Rustlers Roost and Quest 29 Open-Cut Mine Redevelopment

Supplementary Environmental Impact Statement (SEIS)

September 2022

Figure 1 Conceptualisation of groundwater surface water connection

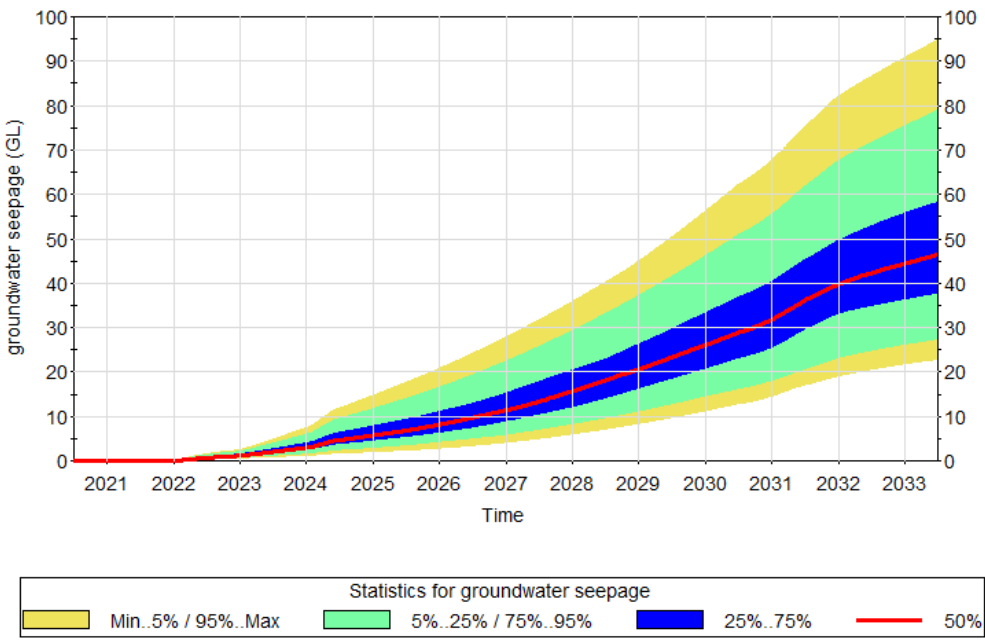
12	Groundwater drawdown - Section 7.3, and Appendix H	Hydrological processes	Comment <u>Drawdown from pit dewatering</u> The current (regional scale) groundwater modelling has shown that the calculated 1 m drawdown from the pit dewatering extends 5 km to the north and 3 km to the south of the Rustlers Roost pits, and 2 km to the south-west of the Quest 29 pits. The baseflow contribution to creeks and streams would normally sustain hyporheic zones, any permanent and semipermanent pools/waterholes, and support associated flora and fauna (e.g. riparian vegetation including potential GDEs) following the wet season. These processes are likely to be interrupted as a result of drawdown and alteration of the natural flow characteristics. Additional Information Required The information is required to clarify and demonstrate riparian vegetation and GDEs will not be significantly impacted by groundwater drawdown, seepage, and discharges from the mine site. 1. Assess (quantify) the pre-mining groundwater contribution (baseflow) to creeks and stream flows where drawdown effects are expected to occur, and	Additional Information Point 1 An assessment of pre mining conditions has been included in the updated groundwater numerical modelling described in response to submission number 7, including an estimates of groundwater contribution to stream flows. This has been cross referenced with the results of the GDE study described in more detail below. Additional Information Point 2 The updated groundwater model has been used to assess any reduction in baseflow contributions (quantity) due to drawdown from pit dewatering. The spatial extent of the drawdown has been compared to the GDE map produced from the additional GDE study described below in more detail to determine whether any GDEs are within the zone of impact. A GDE assessment has been undertaken to assess potential impact of the Project on GDEs and provide an ongoing approach to actively manage the potential risks to GDEs from the Project activities. A summary of the results and recommendations is provided below and Appendix P provides the GDEs assessment report with detailed information on the assessment scope, results and recommendation to mitigate any potential impact on GDEs. The GDE assessment has concluded the following:

No.	EIS Section	Theme or Issue	Comment / Requested Additional Information	Required Action / Response
				LOWER REACH – PREDOMINANTLY GAINING, PERMANENTLY CONNECTED STREAM REACH  Stream losing to bank storage and aquifer Bank storage Alluvium Bedrock MID-REACH – LOSING/GAINING, SEMI-PERMANENTLY AND NON-PERMANENTLY CONNECTED STREAM REACH  Stream losing to bank storage and aquifer Bank storage Alluvium Bedrock UPPER REACH – LOSING, DISCONNECTED STREAM REACH  Stream losing to bank storage and underlying aquifer Bank storage Alluvium Bedrock Note: Occurs during and following large and sustained stream flow events FALLING STREAM  Stream gaining from bank storage return Bank storage Alluvium Bedrock MID-REACH  Stream gaining from bank storage return Bank storage Alluvium Bedrock UPPER REACH  Bank storage drains away Alluvium Bedrock Note: Occurs as stream flow recedes DRY SEASON  Gaining from local groundwater system Alluvium Bedrock MID-REACH  Gaining if streambed intersects water table (i.e. window to water table) Alluvium Bedrock UPPER REACH  Gaining from local groundwater system Alluvium Bedrock Note: When bank storage has depleted streams return to pre-stream flow condition Legend Steady state water table Transient water table Stream fluxes: Loss Gain Groundwater flow Figure 3 2 - Conceptualisation of groundwater surface water connection CDM Smith

The WMP has been updated and includes consideration of GDEs based on the recent assessment (refer to Appendix P). The development of a Groundwater Dependent Ecosystem Monitoring Program (GDMP) is proposed and will be implemented during the Project so any potential impact to GDE is avoided or minimised to be as low as practicable. The proposed monitoring program is driven by the GDMP objective that aims to protect the ecological condition of

Figure 1 Sediment Basin Type D Detail

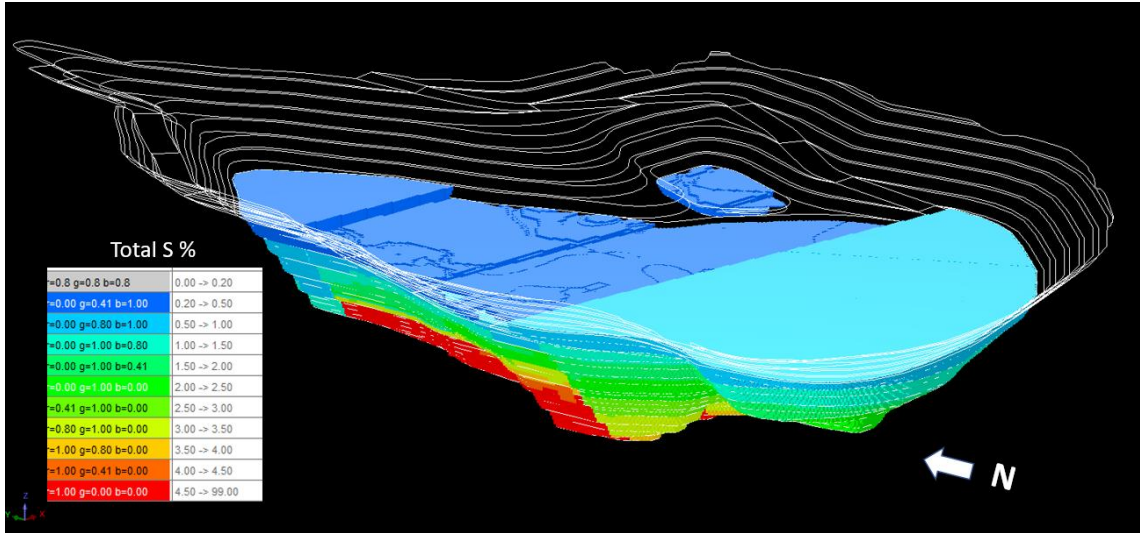
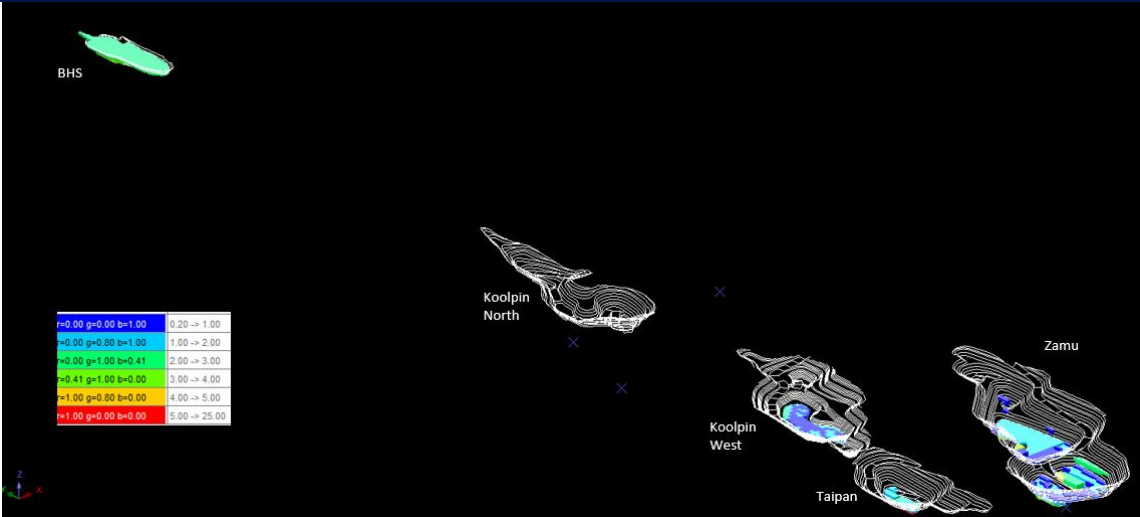
16	Section 6.2.1 of Appendix H	Inland water environmental quality	Comment The TOR requires a detailed description of all construction and operational aspects including WRDs. The Draft EIS states: <i>‘given the small catchment area associated with each WRD, potential runoff from the WRDs will be captured into dedicated decant dams, with the runoff water treated before release to the surrounding creeks’.</i> Additional Information Required Clarify the design, construction, and operation of WRDs and provide additional information on: 1. Risk of contamination of runoff from WRDs with metals and other contaminants. 2. The details of decant dams for WRDs 3. The details of water treatment for runoff water prior to release.	Additional Information Point 1, 2 and 3 The top cladding of the WRDs will be slightly domed to prevent water collecting, facilitate runoff and limit seepage. Rock lined drainage trenches will be the initial receiving structure for WRD runoff. The drainage trenches will capture the WRD runoff and slow the velocity of water running down the 17 degree slope to prevent erosion. The erosion and sediment planning for the project incorporates two types of basis for capturing and treating WRD runoff prior to discharge: 1) Catch drains along the WRD contours; 2) Temporary check dams; and 3) Sediment basins (termed the decant dams in the extract). The proposed network of drains and retention structures is identified in Appendix L of the Draft EIS and is based on analysis in accordance with the International Erosion Control Association (IECA) best practice guideline Best Practice

No.	EIS Section	Theme or Issue	Comment / Requested Additional Information	Required Action / Response																																																																																																												
				Erosion and Sediment Control (IECA 2008). Additional information on the design and construction of the WRDs is provided in Appendix J of the SEIS. A map showing all decant dams for the Project (including WRDs) is provided in Appendix D.2 of Appendix L Erosion and Sediment Control Plan of the Draft EIS. However, Appendix L of the Draft EIS has adopted a different terminology for the decant dams and called it as ‘Sediment Basin’. Figure 1 below is an extract of the figure provided in Appendix D.2 of the ESCP which shows the location of all decant dams (referred to as ‘SB’ – Sediment Basin) in blue, the catch drains in green and check dams in black. Table 6-1 in Appendix L Erosion and Sediment Control Plan of the Draft EIS provides calculation of maximum sediment basin capacity, as shown in Table 1 below. Table 1 Calculation of Maximum Sediment Basin Capacity

No.	EIS Section	Theme or Issue	Comment / Requested Additional Information	Required Action / Response																																													
				Sediment basins proposed for the Rustlers Roost, Quest 29 mining areas and accommodation camp are sized as Type D basins, which assume dispersive soils requiring the use of flocculating agents for settlement. Basin design will be revised prior to implementation of mine development to ensure the most efficient basin configuration is adopted. Final basin location will be subject to final site layout; however, the following criteria will apply: ▪ Located to maximise collection of sediment-laden runoff generated within the site; ▪ Not located within waterways or drainage channels; ▪ Located above the 1 in 5-year ARI; ▪ Have suitable access for maintenance; and ▪ Placed near site perimeter for ease of dewatering. Basin construction will incorporate the following elements: ▪ Earth embankments to be certified as structurally sound by geotechnical engineer/specialist; ▪ Stable inflow system (e.g., rock chute); ▪ Minimum 3:1 length to width ratio (may require internal baffles); ▪ Primary outlet (e.g., siphon, perforated riser) for controlled release; ▪ Emergency spillway (minimum design storm 1 in 50-year ARI); and ▪ Marker to identify the sediment storage zone depth. Basins are to be managed as follows: ▪ Discharged within 5 days of cessation of rainfall (min 25 mm); ▪ Controlled sediment basin discharge to be in accordance with the MMP and project approvals; ▪ Prior to discharge, water quality to meet project discharge criteria specified in site Water Management Plan (flocculant or coagulant may be required); ▪ Designed to ensure easy and safe access to dose retained water with flocculants as required; ▪ Marker peg to be installed to indicate sediment storage capacity; ▪ Removal of sediment where sediment storage capacity exceeds 50% and disposal/management of sediment so as not to create an erosion or pollution hazard; and ▪ Be regularly monitored to ensure structural integrity is maintained, including inlets and outlets. Surface water guideline values that will apply to release of captured water from the basins are included in Section 5.2.1 of Appendix Q of the SEIS (Water Management Plan). The values are based on the based on a CSIRO review of SSTV for Tom’s Gully mine for Mount Bunday Creek (Stauber and Batley 2018). These are listed below:
